Quality Control Check Report. Stage: After Finishing Stage III (Villas)

Villa No	A-211	Other		Sl. No.	42845
Company	MRGV	Project	BRGV	Phase	
Prepared by	Saikhina	Sign	Saikhina	Date	18/03/24
Project Manager	Saikhina	Sign	Saikhina	Date	18/03/24
Previous stage report no.	42684	Report filed and signed by PM	☒ Yes ☐ No		
Checked By MD on		MD Sign		For filling	☐ Yes ☐ No
Recommendation: ☐ Stop further work. Submit ATR on QC report to QC team. Proceed only after recheck by QC. ☐ Stop further work. Proceed with work after submitting ATR on QC report to QC team. ☒ Proceed with further work only after making corrections pointed out in the QC report. ATR not required. ☐ Proceed with further work. ATR not required.

Description	Direction	Owners & Developers :	Date :	23.07.2021	Promoted by
ELECTRICAL PLAN LAT NOS. 101, 103, 105, 107, 109 & 111		Modi Realty Genome Valley LLP	Prepared By :		Modi Properties Pvt Ltd
		Project Name & Phase :	Approved By :	Soham Modi	
		BRGV	Signature :	N.T.S	
			Phone: +91-40-6633555

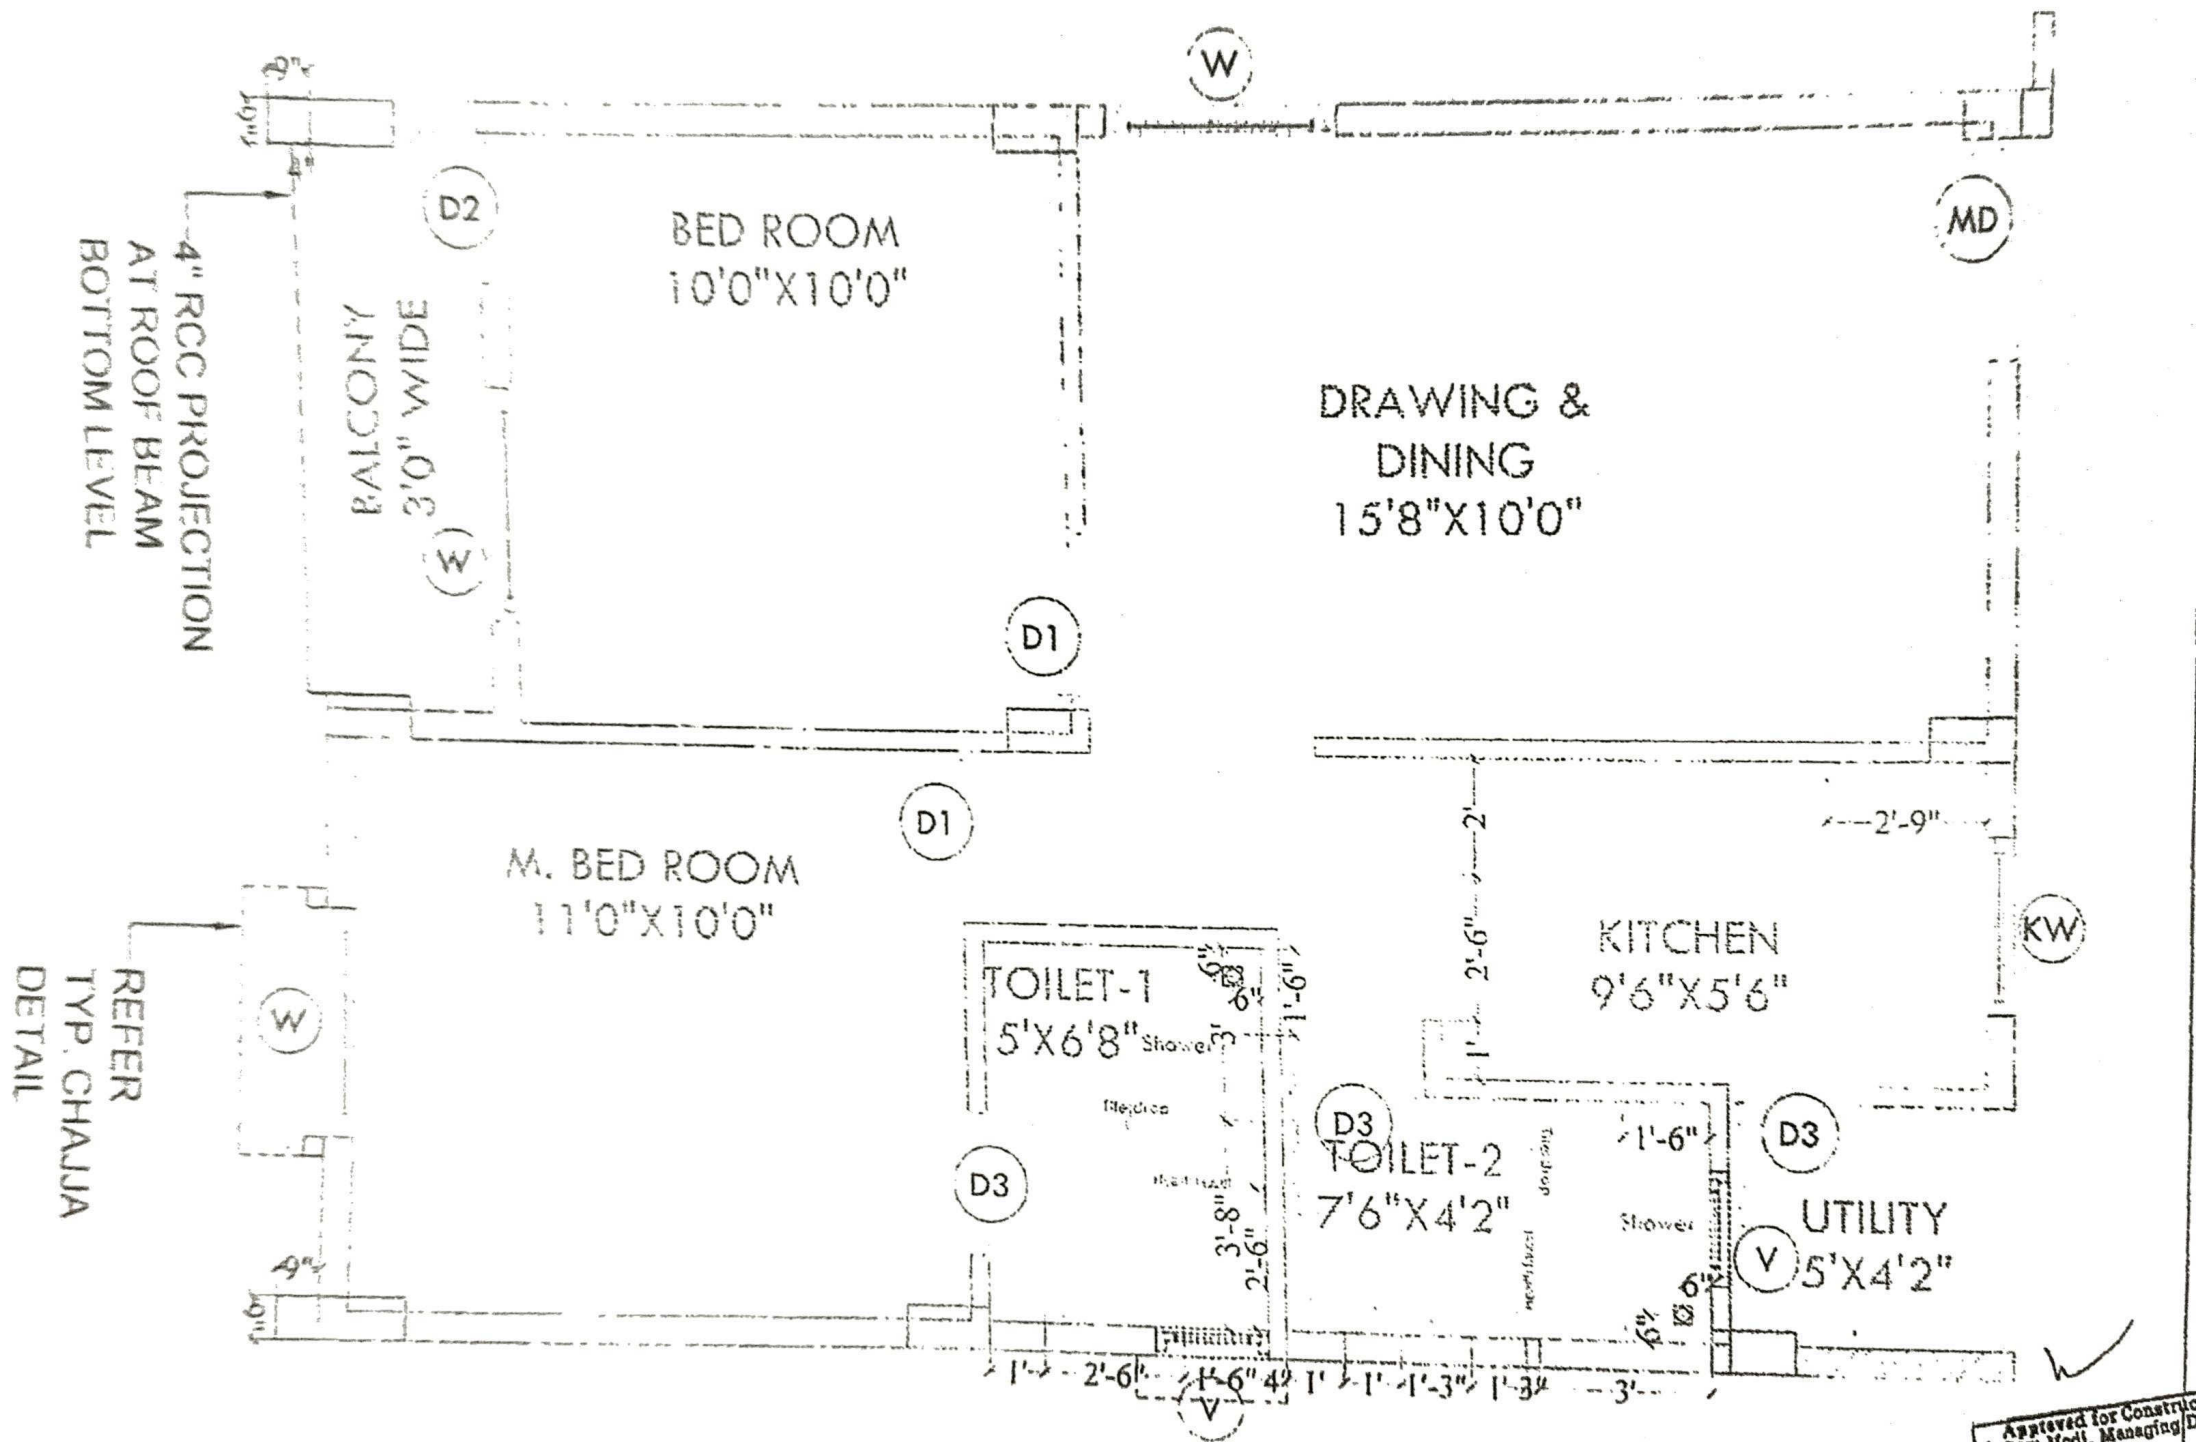
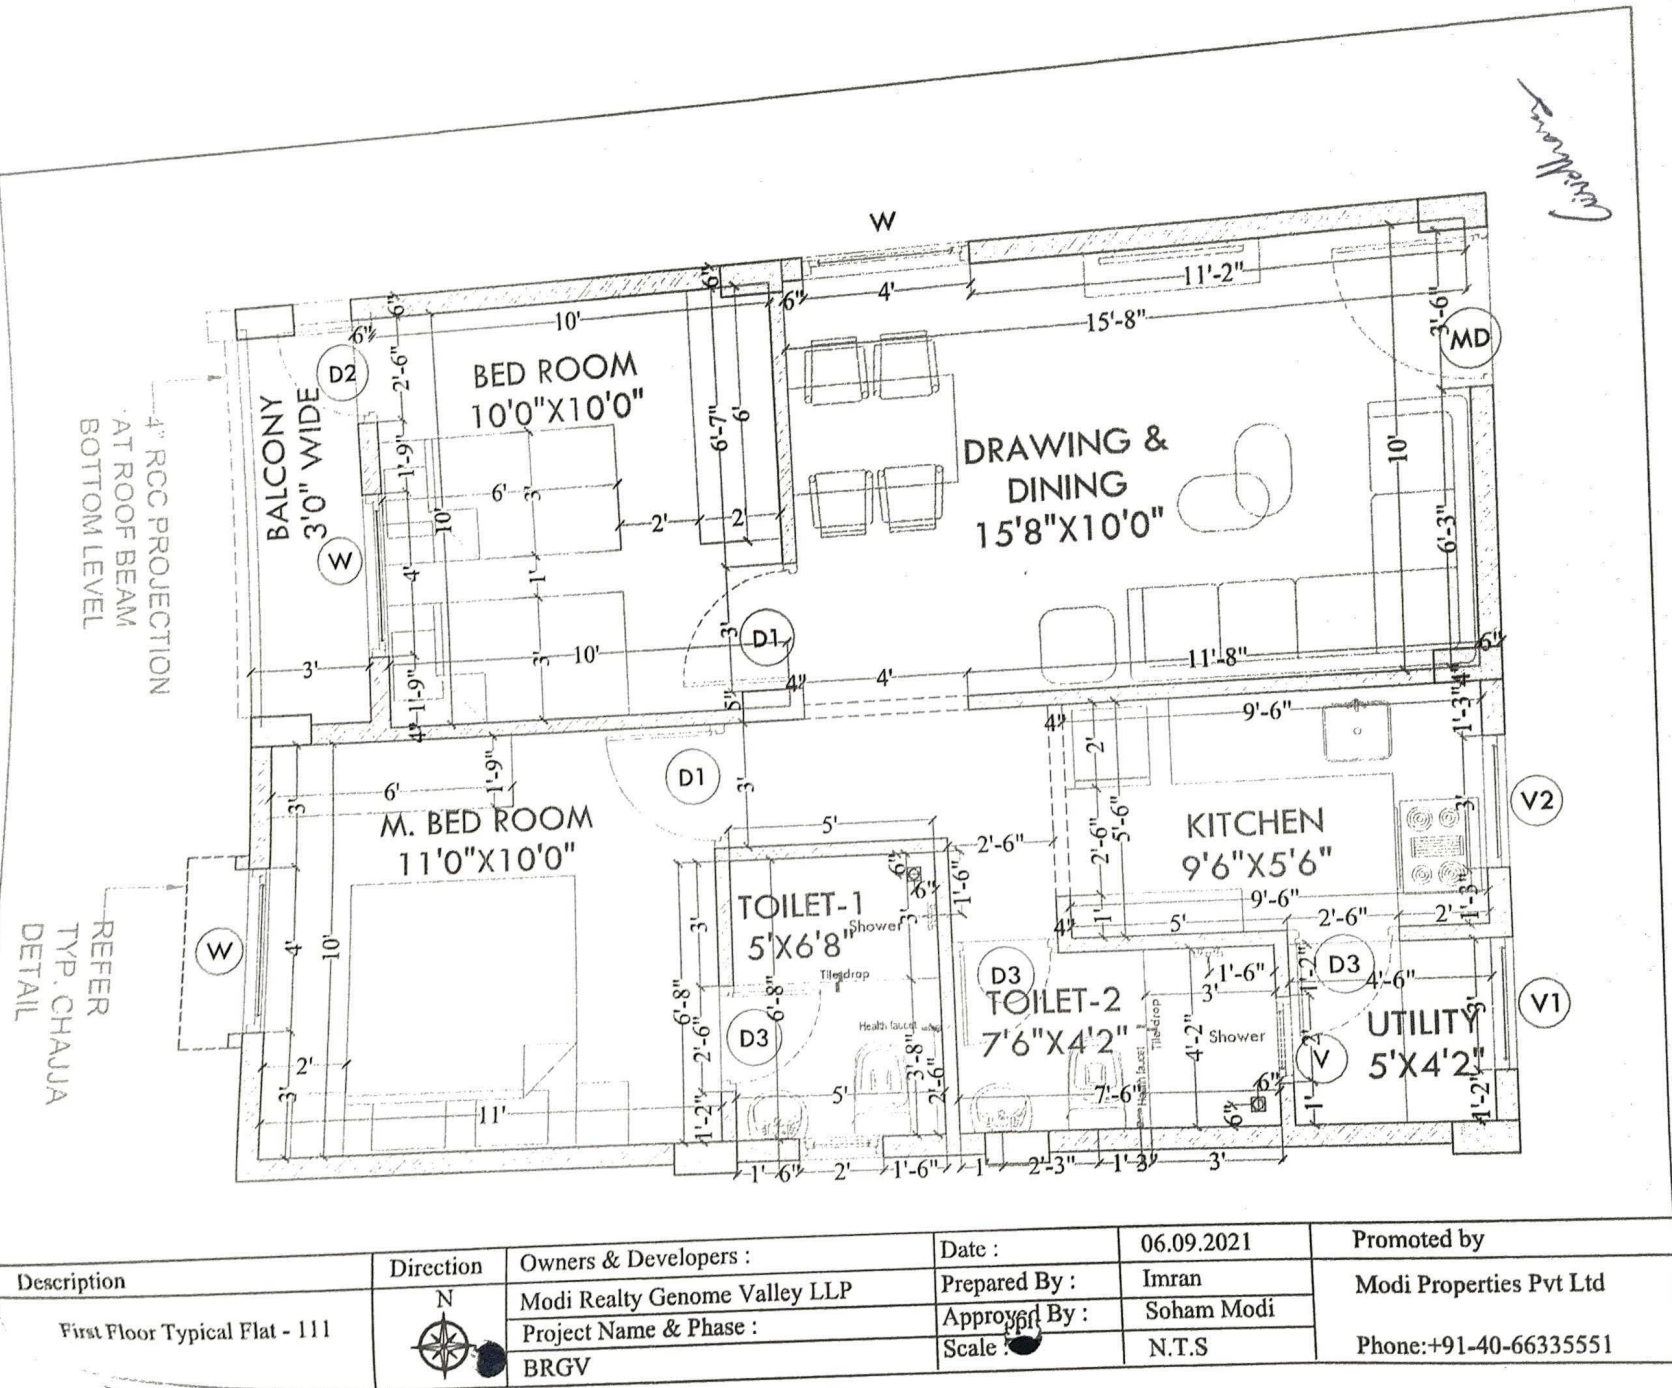
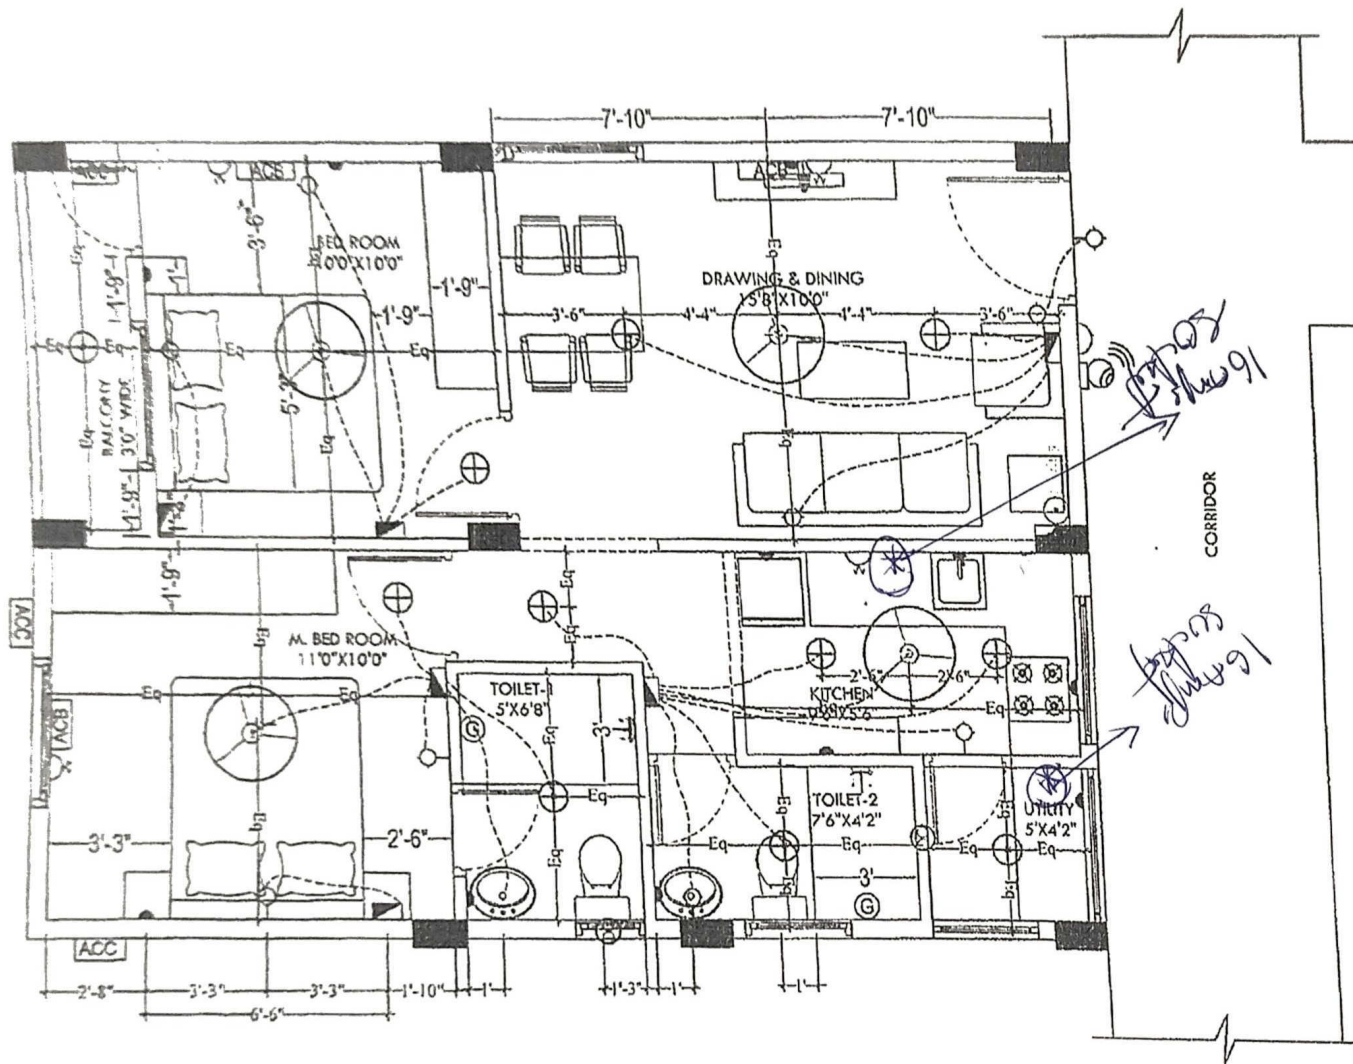
Changes in electrical points: (mark on plan)

- 1) Need 16 amp socket 2 nos in kitchen
- 2) 16 amp socket 2 nos in Utility for Washing machine.
- 3) In Balcony, need one extra plugpoint and switch.
